E4448A-15

S E R V I C E N O T E

E4448A - PSA Series Spectrum Analyzer

Internal Alignment Failures for PSA Series Spectrum Analyzers Manufactured Between January 2004 and February 2006 Caused by Low Power Output from A9A1 DRO on A9 Second LO Assembly

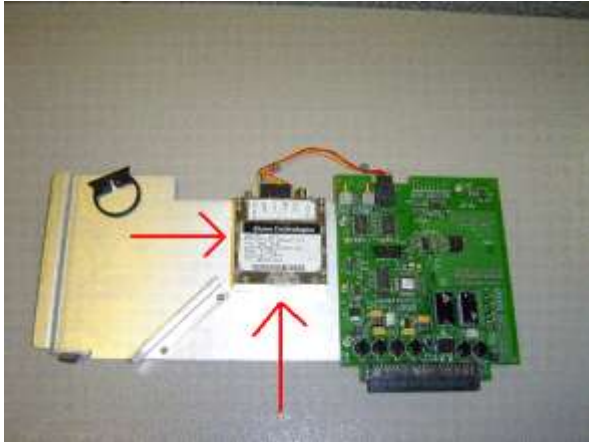
Verify the alignment failure by looking at the error queue for the error message “-340, Calibration failed, Align_2ND_LO_PWR”. Press [System] <Show Errors> <Next Page>. Typically, when the Second LO power is too low, it will be the first failure listed in the alignment queue, which will be at the bottom the Second page of alignment errors (as shown below):
